Whites Point Quarry & Marine Terminal

REVISED PROJECT DESCRIPTION

Debris Cycle Schematic
 Years 16 - 20
 Plan OP 4-12-R1

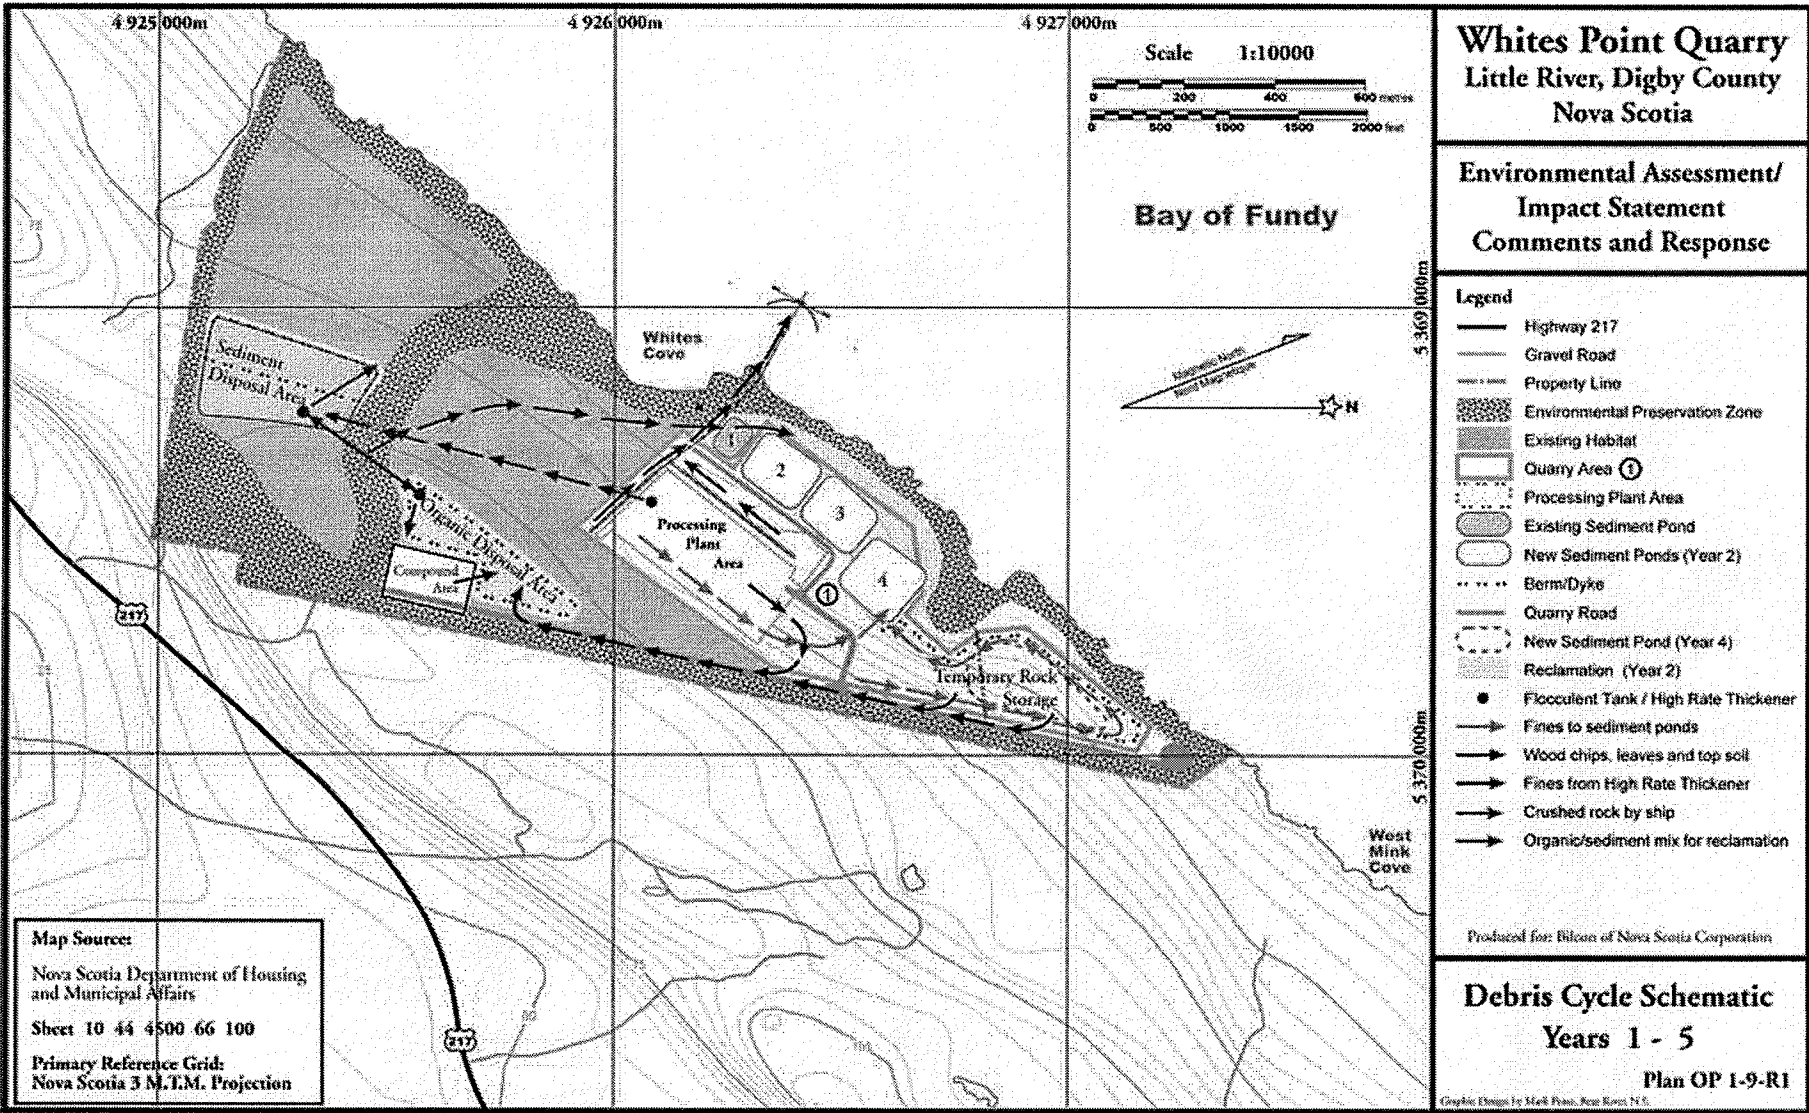
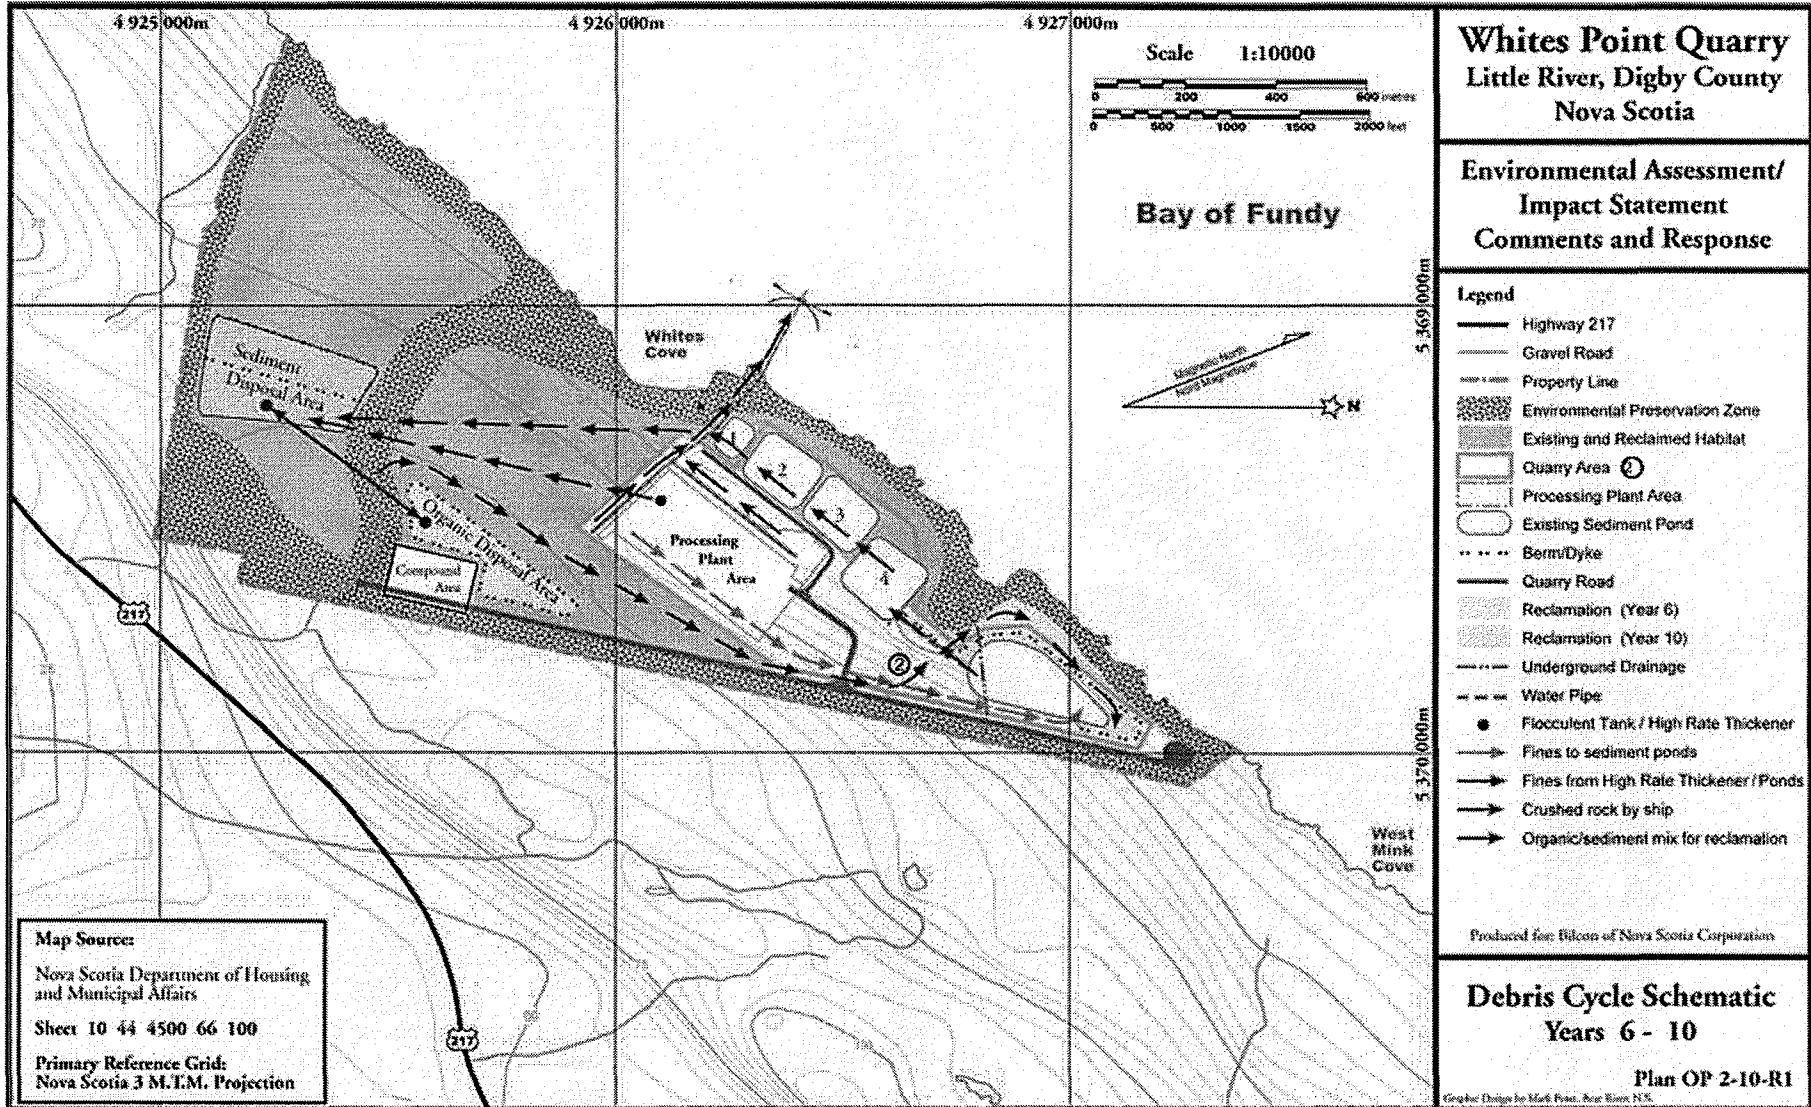
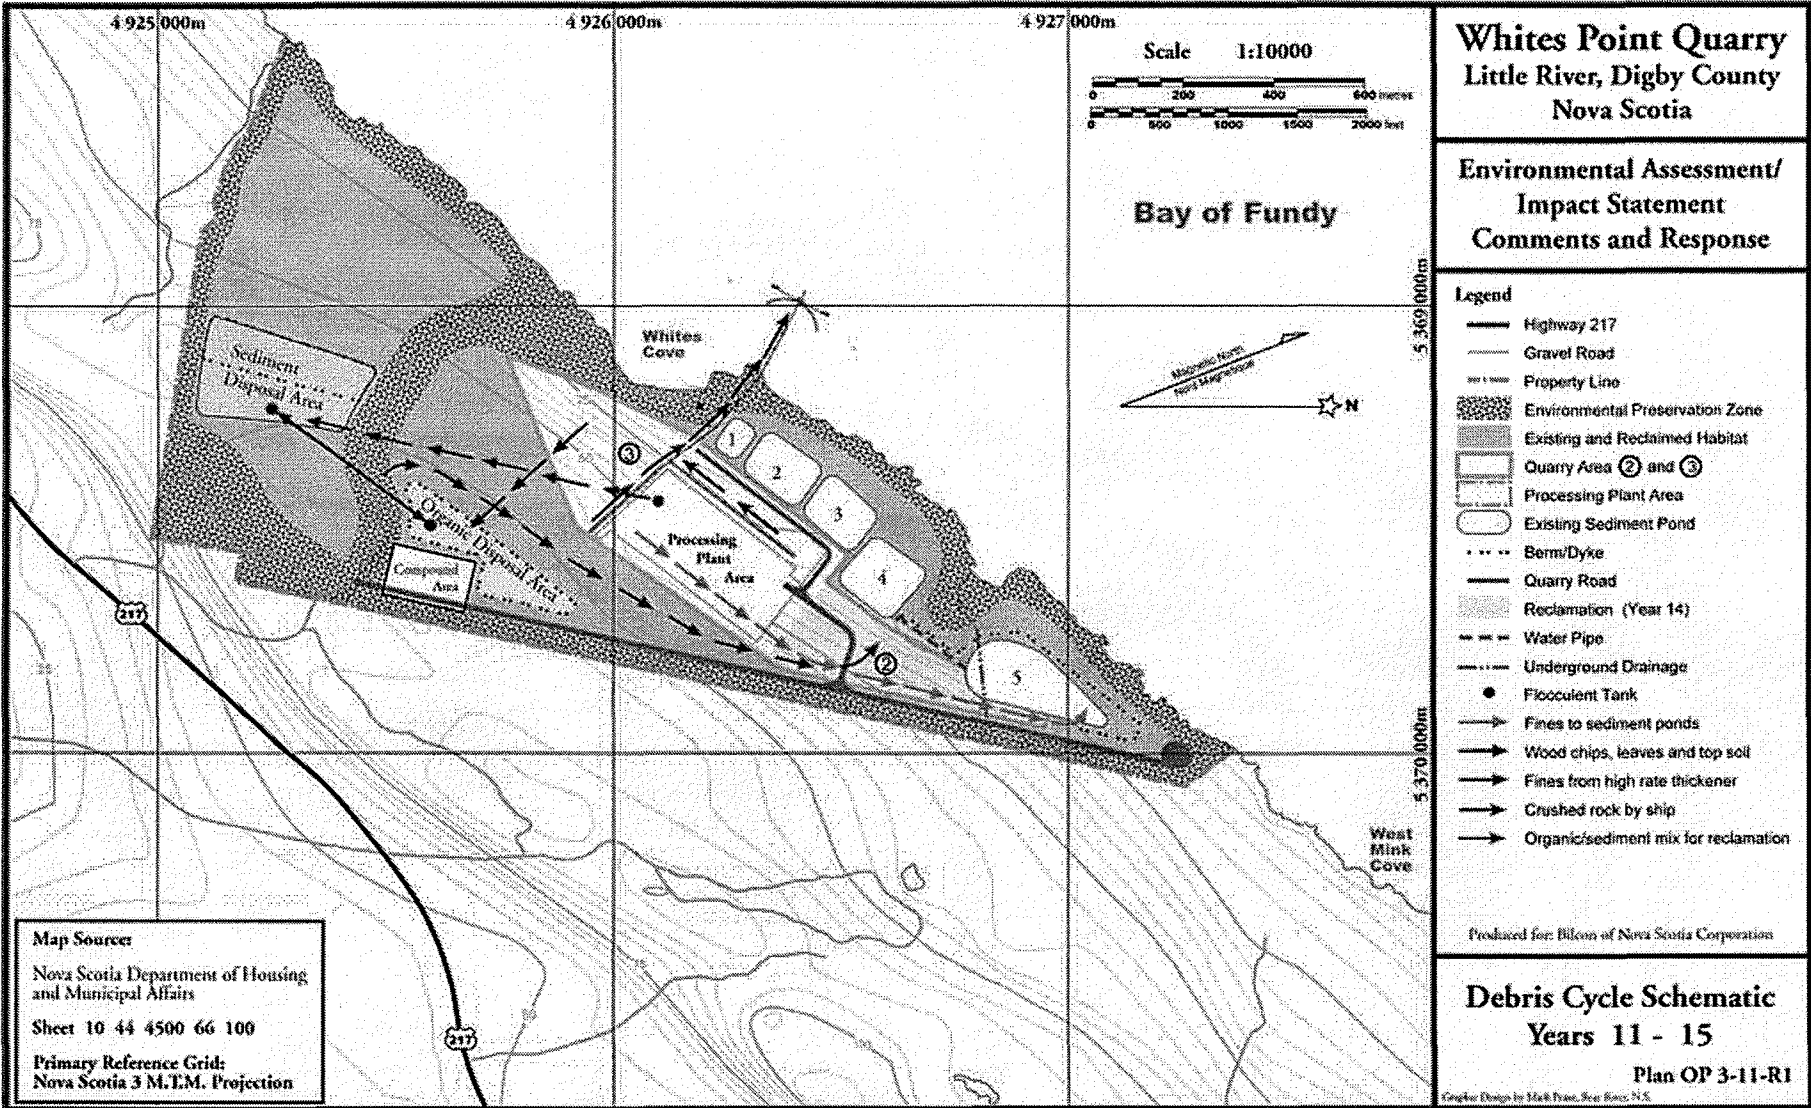
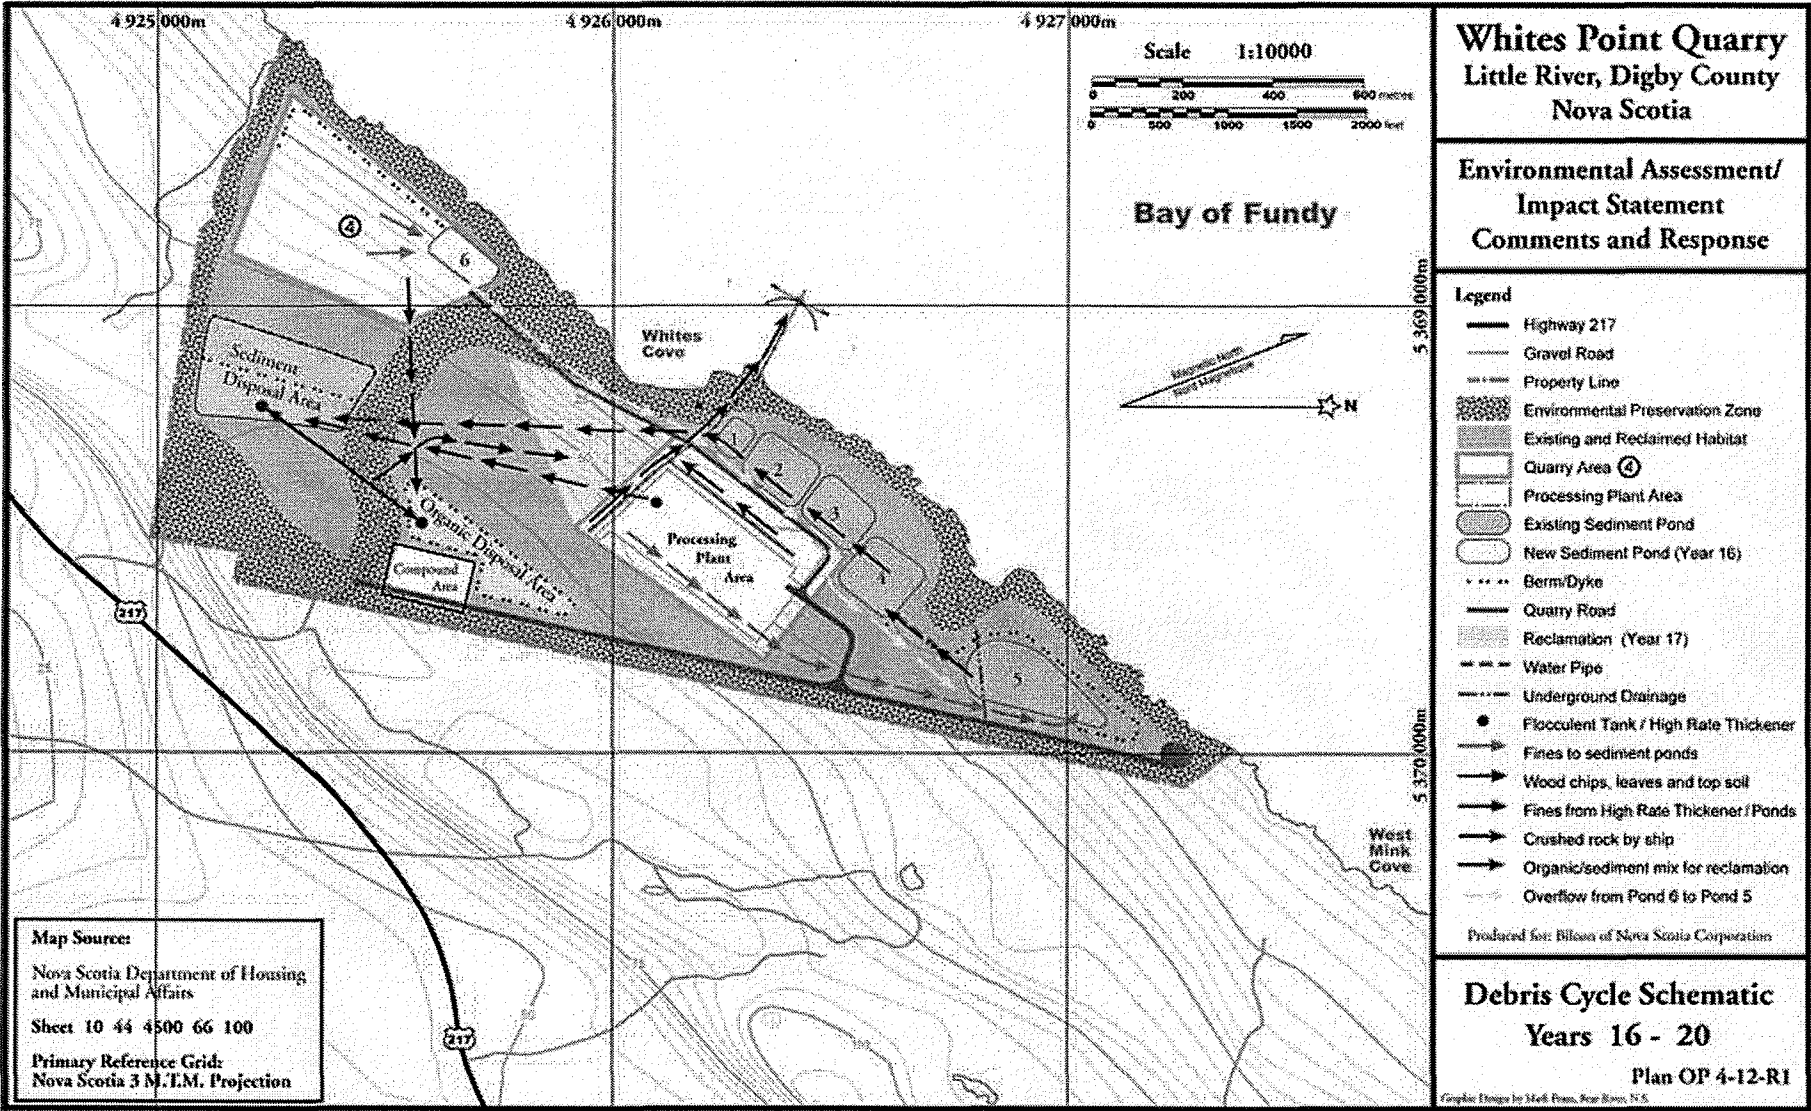
In view of the planned component relocations of the quarry operations, how can subsequent five-year plans be similar? Provide the five-year plans for subsequent periods.

The debris remaining from the crushing process will initially be stored in designated areas and subsequently used in the reclamation process. **Plan OP1-9 – Debris Cycle Schematic** shows the track of debris for the initial 1-5 years of the quarry operation. Subsequent five year periods are shown in **Plans OP1-9-R1 through OP7-15-R1**.

Topsoil and chips from the clearing and grubbing process will be transported to the organic disposal area in the southeast corner of the site for temporary storage in years 1-30 and to the disposal area to the south side in years 30-50. These areas will be bermed to prevent material washing further down the slope.

Fines from the exposed operations area will be collected in the settling ponds which will be periodically emptied and the fines transported to the sediment disposal area in the easterly area of the site for temporary storage.

Fines from the washing operation will be directed to the high rate thickener where, following dewatering, they will be pumped to the sediment disposal areas to the south side for temporary storage. These sediment disposal area will be bermed to prevent migration of the fines further downslope.
